I-405 Improvement Project
Amendment 1 - Noise Study Report

Seal Beach Tennis Court Center

In Orange County from SR-73 to the I-605 Interchange

APRIL 13, 2012 FIGURE 23

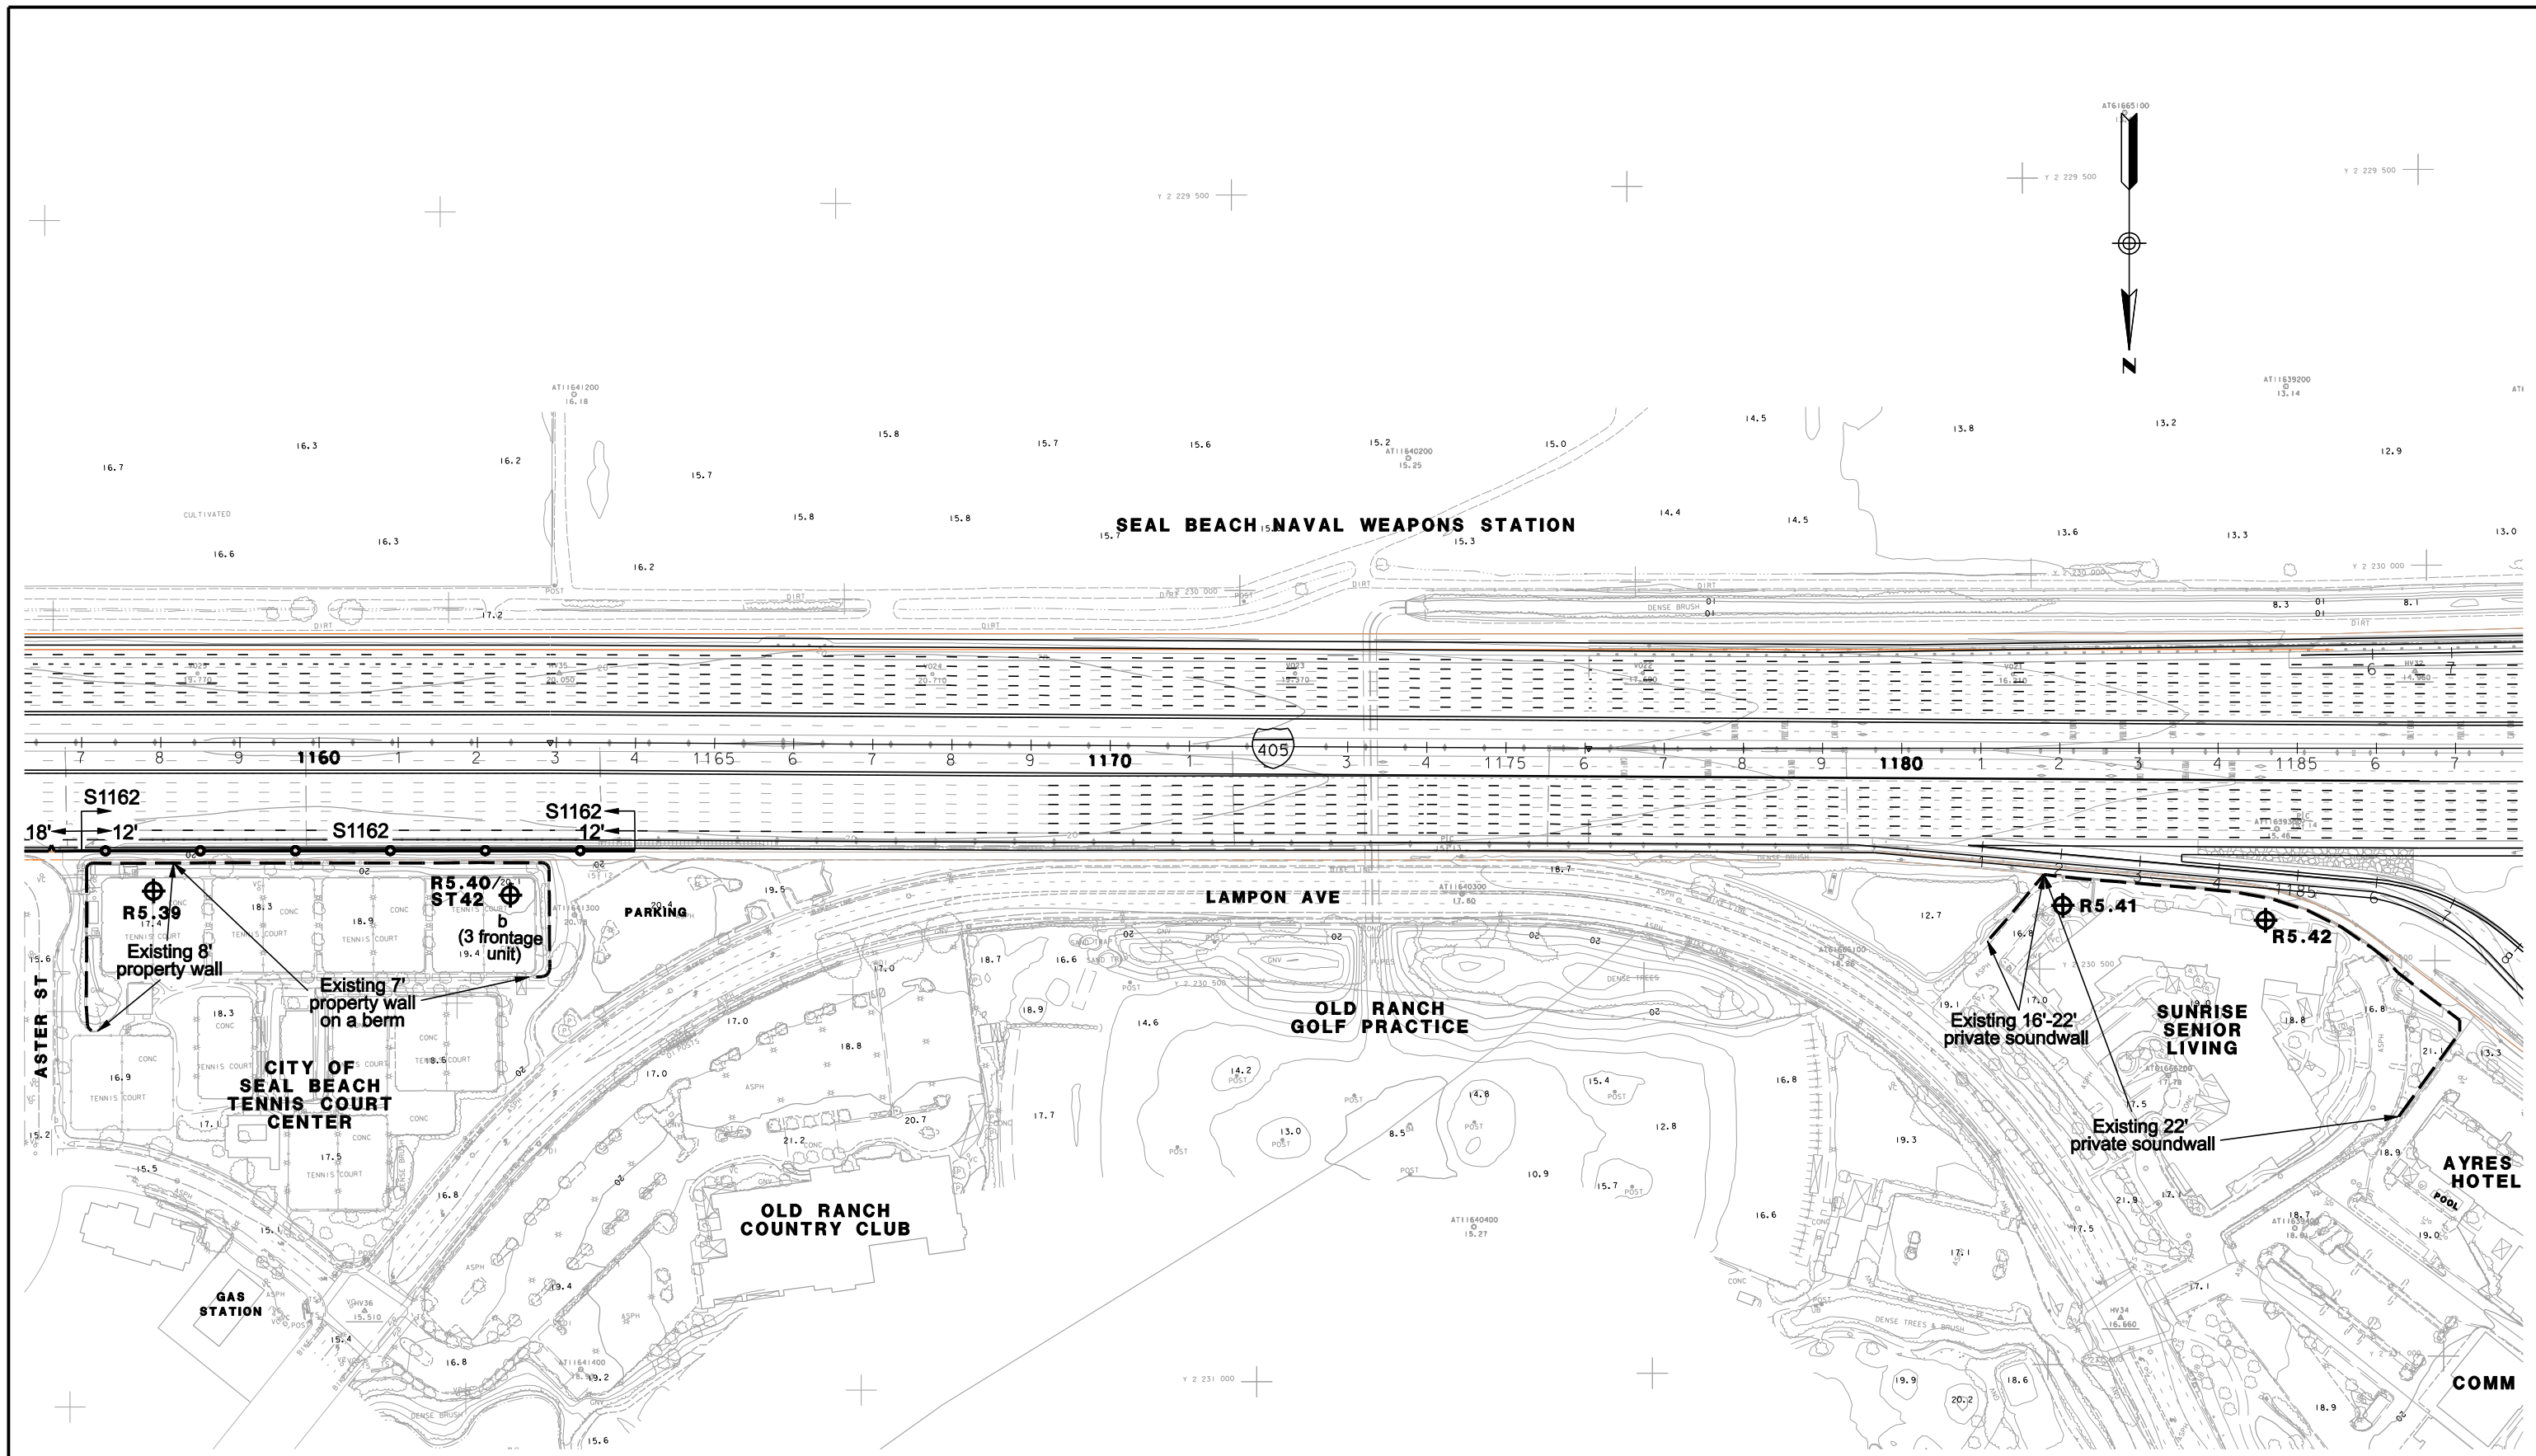
The final Noise Study Report dated June 2011 conducted for I-405 Improvement Project had identified Soundwall S1162 adjacent to the City of Seal Beach Tennis Court Center, as a feasible abatement measure for Alternatives 1, 2, and 3. However, NADR had concluded that this soundwall cannot be constructed within determined allowance for any build alternatives; therefore, it had concluded that this soundwall will not be considered reasonable for Alternatives 1,2, and 3. Upon further review it was determined that because the length of tennis court area along I-405 is approximately 550 feet, a higher number of benefited units –equivalent to benefited residence- can be considered for the noise analysis. As every 100 feet of exposed area is considered one frontage unit, six frontage units should have been considered in for the noise analysis instead of two.

The following are revised tables for each alternative that show the corrected frontage units and attached are corrected figures. It was assumed that Receivers R5.39 and R5.40 each represent three frontage units. NADR will also be revised to consider this correction.
